**Addendum No. 2**  
**November 17, 2021**

Project: Corsica-Stickney H.S. Addition  
Corsica, South Dakota  
Architect's Project No.: 2910

Architect: Architecture Incorporated

SECTION DETAIL  
SCALE: 1 1/2" = 1'-0"

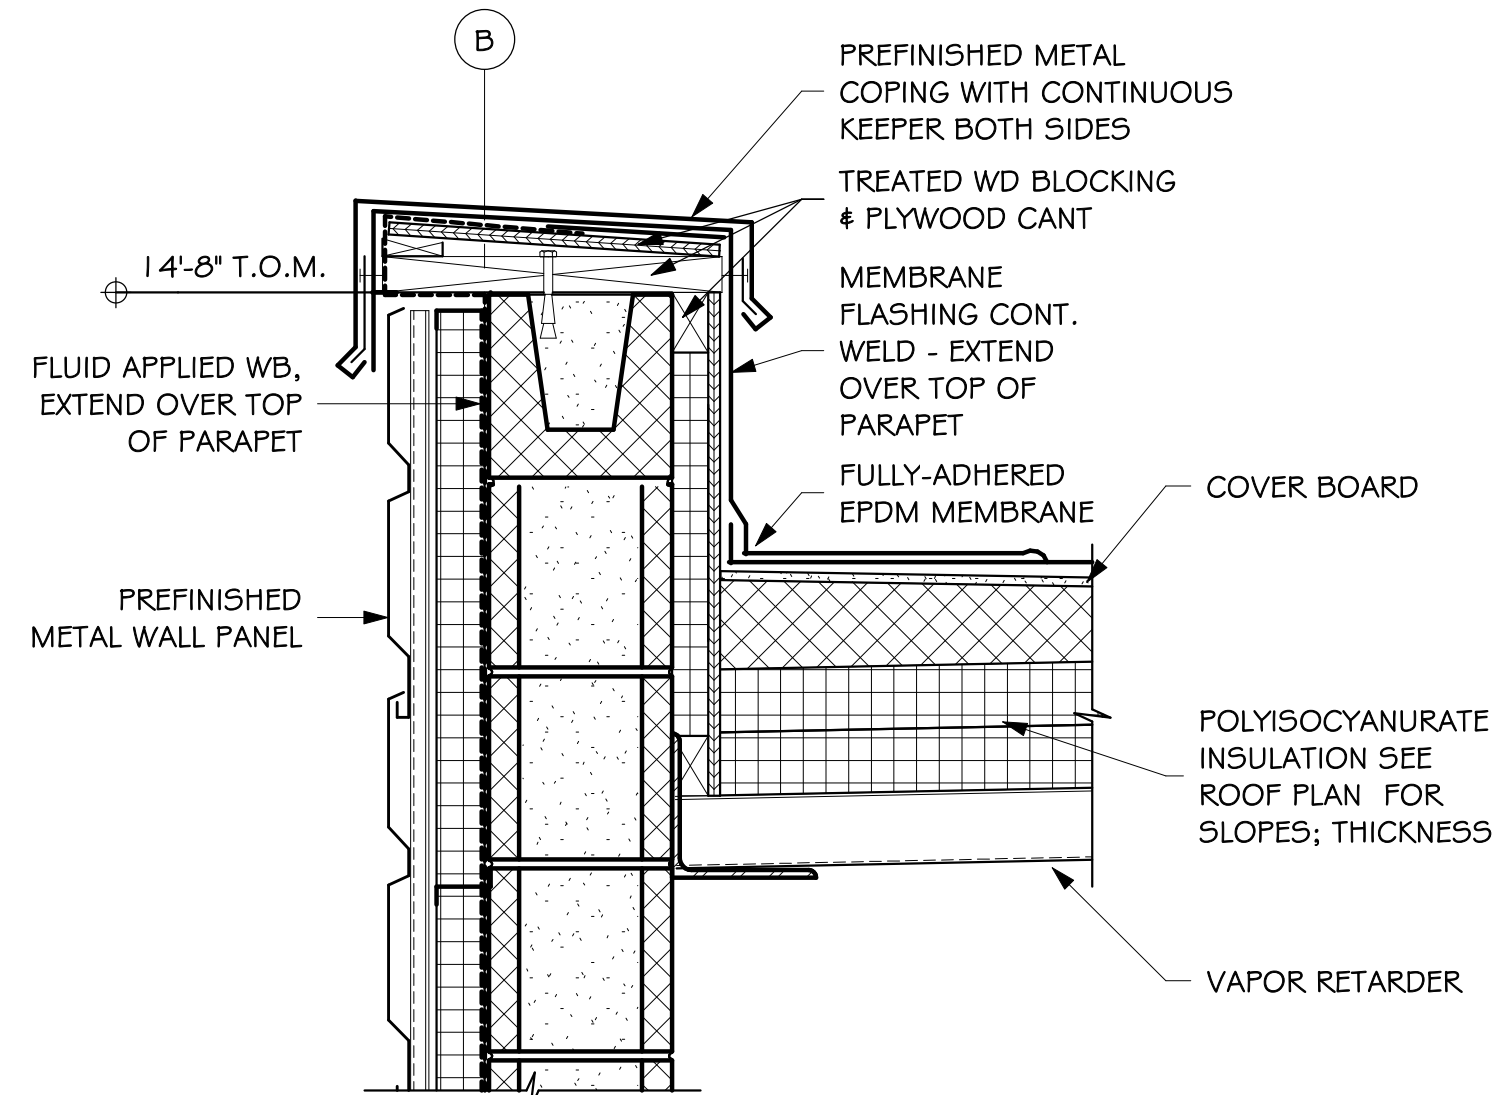
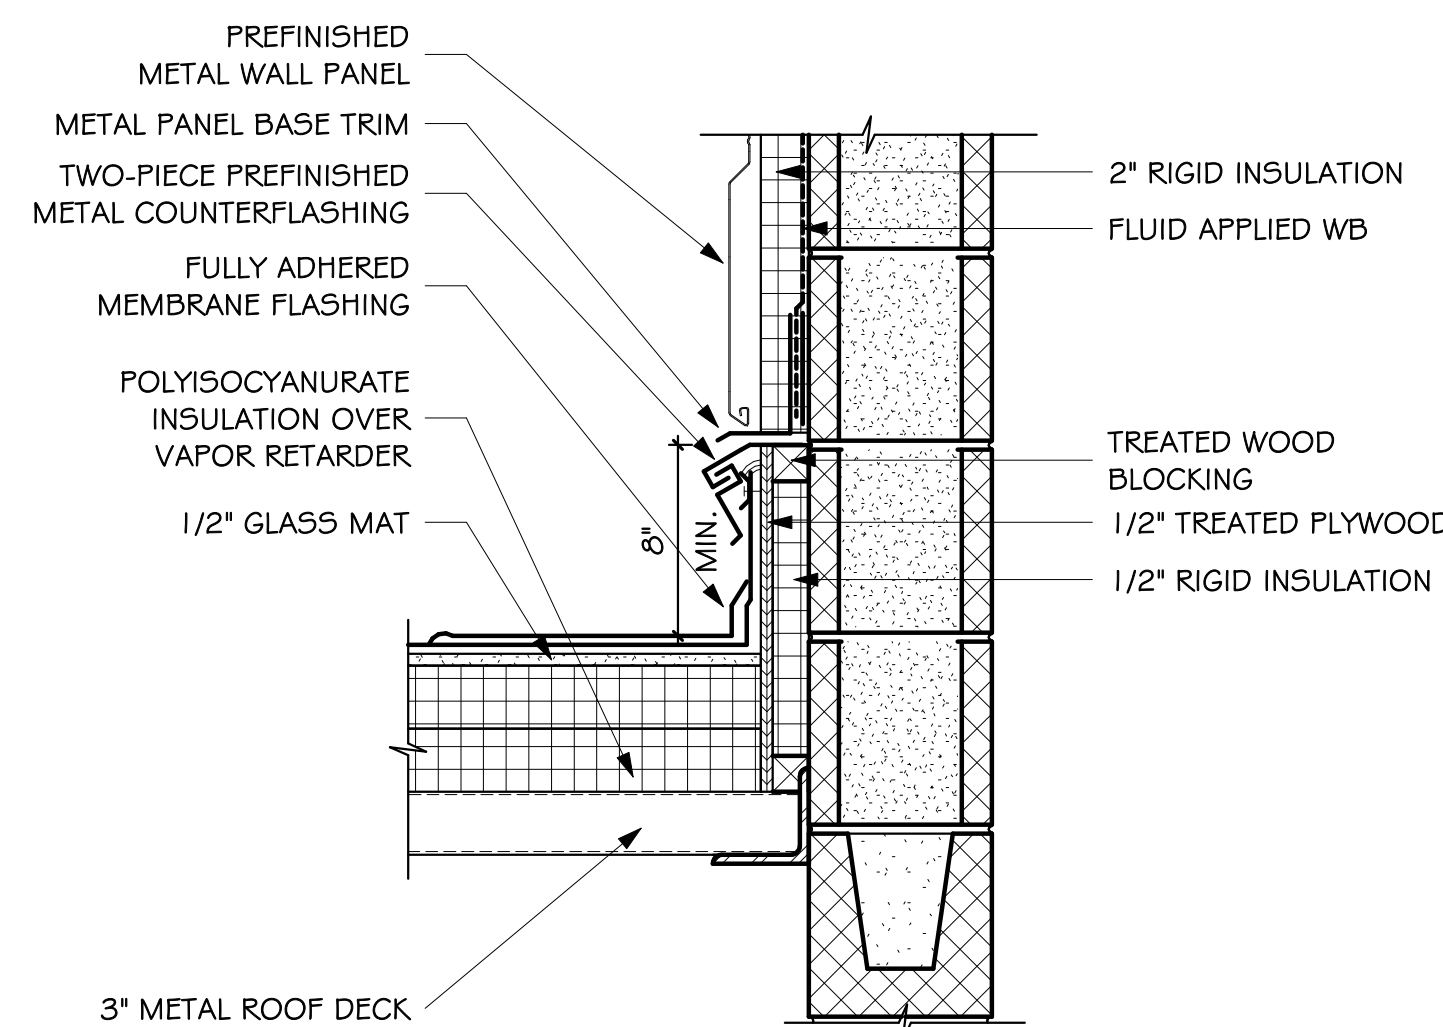
- a) **MODIFY** Storefront SF3, SF4, SF5 and SF 6 to 11’-0” in height
  - b) **MODIFY** Details 16/5.11 and 23/5.11
- 10) **SHEET 5.40 SECTION DETAILS:** See new sheet clouded and tagged with “2”

- a) **MODIFY** Detail 9/5.40
- 11) **SHEET 5.41 SECTION DETAILS:** See new sheet clouded and tagged with “2”
  - a) **MODIFY** Detail 6/5.40
